Department of Energy Responses to the Nuclear Regulatory Commission Request for Additional Information on the Draft Waste Incidental to Reprocessing Evaluation for Vitrification of Low Activity Waste

**Department of Energy Responses to the
Nuclear Regulatory Commission
Request for Additional Information on the
Draft Waste Incidental to Reprocessing
Evaluation for Vitrification of Low Activity
Waste
(Revision 1, Consolidated Response)**

July 2021

Figure 2-2-1. Strontium-90 Plumes in the 200 East Area.

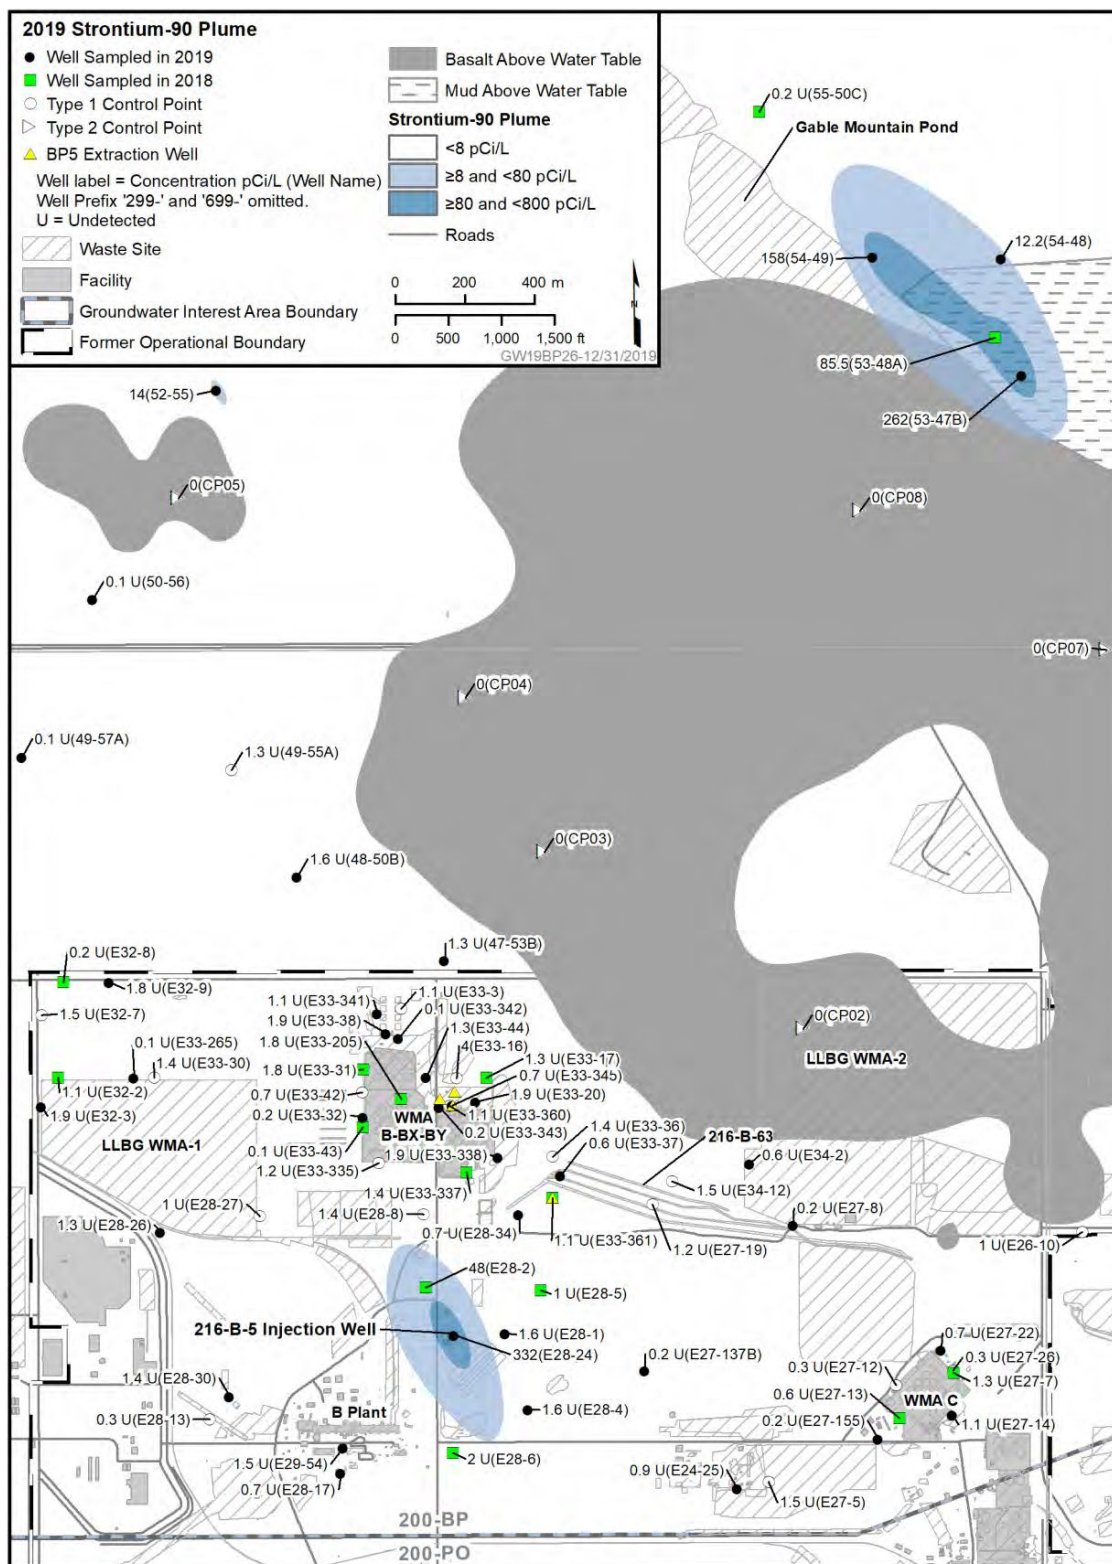
The hypothesis that the vadose zone model should be able to produce transport times for ^{90}Sr of about 40 years to reproduce the observed ^{90}Sr concentrations in the groundwater illustrated in Figure 3-93 on page 3-170 of RPP-RPT-59958 is not unreasonable. The proposed path forward suggested in the RAI to use the PA model to show that the transport of ^{90}Sr is reasonable given assumed historic operating conditions is also not unreasonable.

“Strontium-90 exceeds the 8 pCi/L DWS [*drinking water standard*] near the former Gable Mountain Pond (inactive and dry since the mid- to late 1980s) and near the 216-B-5 reverse well (Figure 9-19 [*reproduced here as Figure 2-2-1*]). About 179 Ci of strontium-90 was discharged to Gable Mountain Pond, with most of it associated with the 1964 PUREX Plant unplanned release (UPR-200-E-34)³⁵. About 7.5 Ci of strontium-90 were injected into the 216-B-5 reverse well between 1945 and 1947³⁶. Because strontium-90 tends to bind to vadose zone sediments, it reached groundwater only at locations where the vadose zone is relatively thin (e.g., <12 m [39 ft] at Gable Mountain Pond) or where waste was injected into the aquifer (216-B-5 reverse well).

Figure 2-3-1. Two-Dimensional Vertical Cross-Section Model of Integrated Disposal Facility Showing Numerical Grid and Surface Barrier Materials.

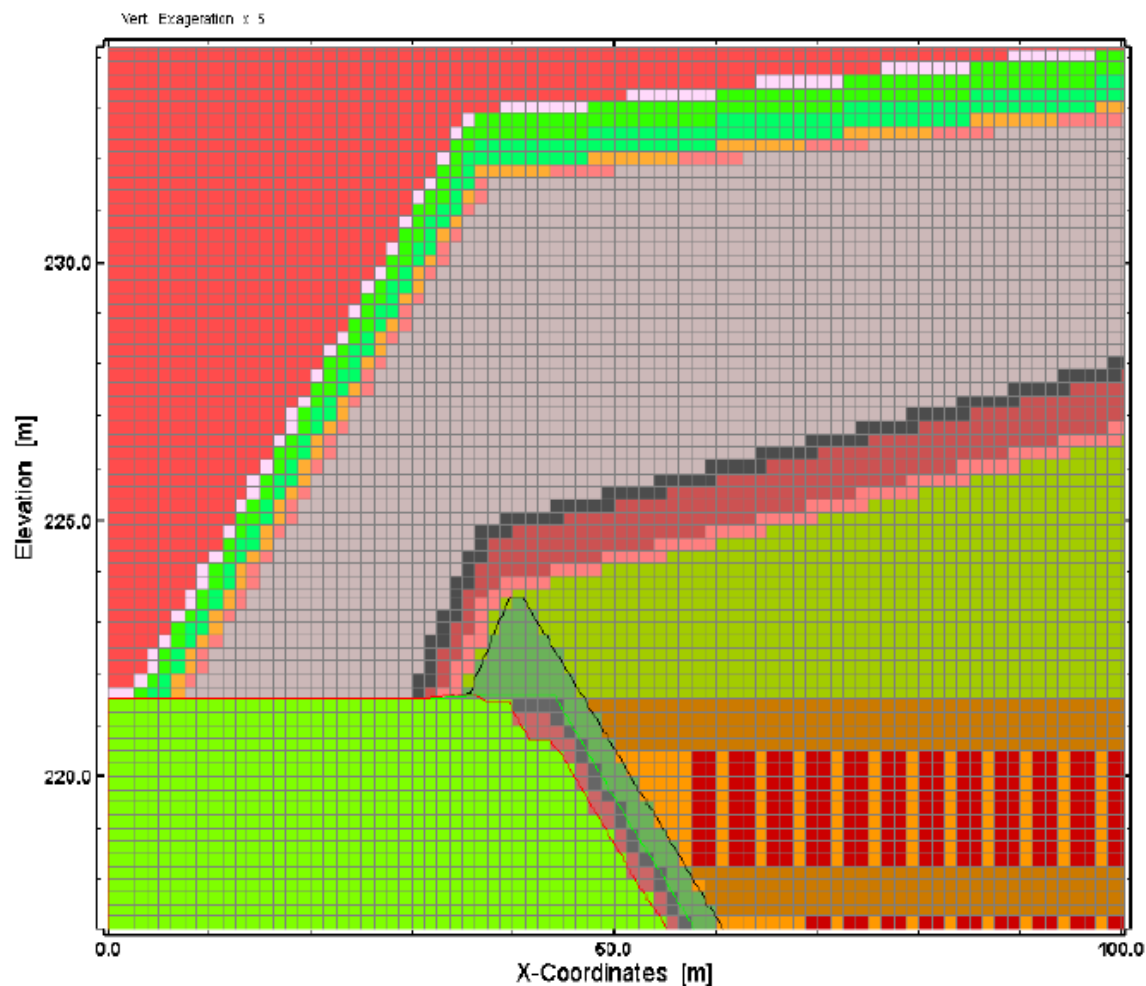
Figure 4-22 from the PA document (shown below), provided the numerical grid and material properties assigned for near-field flow. It appears that some layers are not continuous in the model. It is not clear how the discretization was fine enough to ensure proper precision. The text of the PA document describes the stair-stepped discretization but does not explain how it was determined that the model discretization was sufficient. The potential impact is shown in Figure 5-11 from the PA document (partial figure provided below) where the saturation values and liquid flux rates appear to have large variations as a result of the numerical grid selection.

DOE acknowledges that the discontinuous layers of the engineered surface barrier in the two-dimensional (2D) near-field flow model depicted in RPP-RPT-59958, Figure 4-22 do not physically represent the continuous layers that would be constructed in the barrier above the IDF. The discontinuous nature of the model layers in the surface barrier are a result of the selected grid size used to represent the engineered surface barrier, but DOE believes that the grid size was adequate for the intended purpose of the model, which was to investigate moisture distribution in the vicinity of the waste containers and through the IDF liner system. The simulation results were then used to develop boundary conditions for radionuclide fate and transport simulations; the near-field flow model was not used to simulate radionuclide fate and transport.

Figure 2-8-1. Schematic of Clamp-Pellet Assembly.

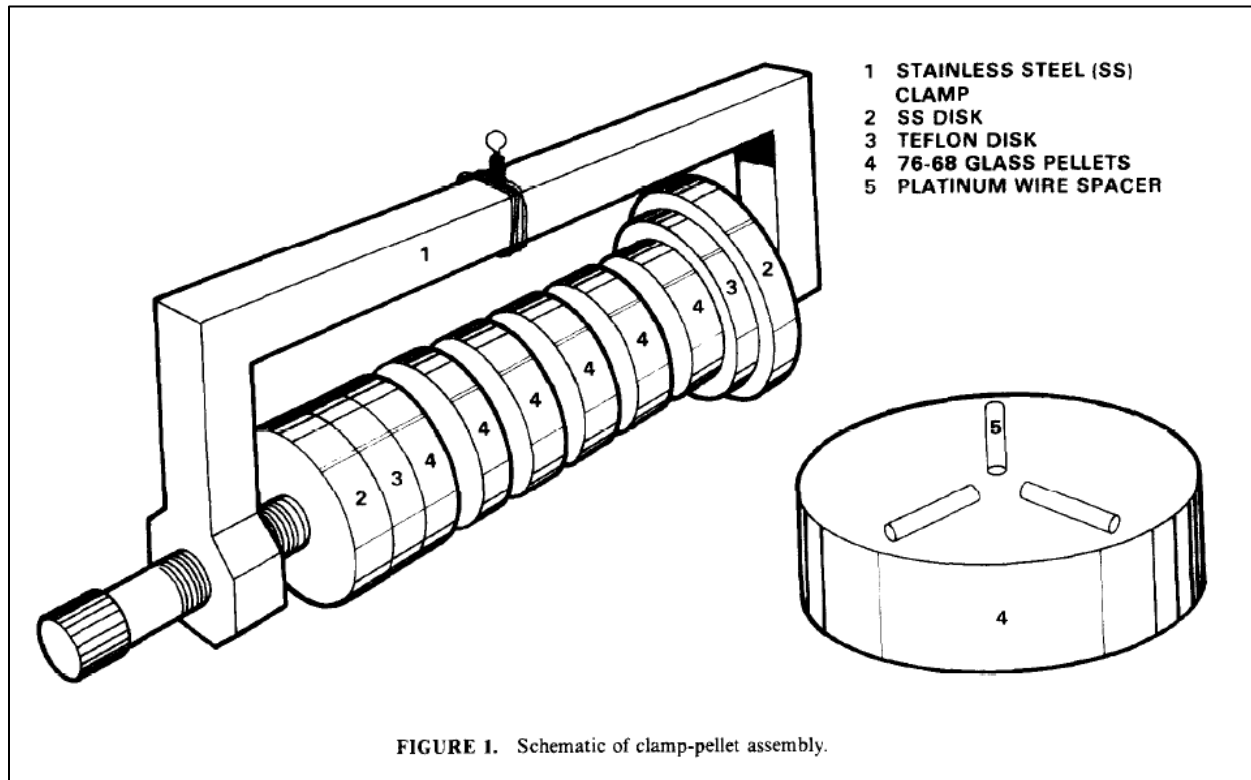
Testing such as that reported in the table provided in this comment provide measurements of α , but do not suggest the impacts of β on dissolution rates. Unfortunately, there has been little direct research to quantify β for nuclear waste glasses. “Effects of Cracks on Glass Leaching” (Perez and Westsik 1981) report the results of glass dissolution experiments using uniform glass pucks separated by platinum wires to simulate cracks. The experimental apparatus is shown in Figure 2-8-1 (a reproduction of Figure 1 from Perez and Westsik [1981]).
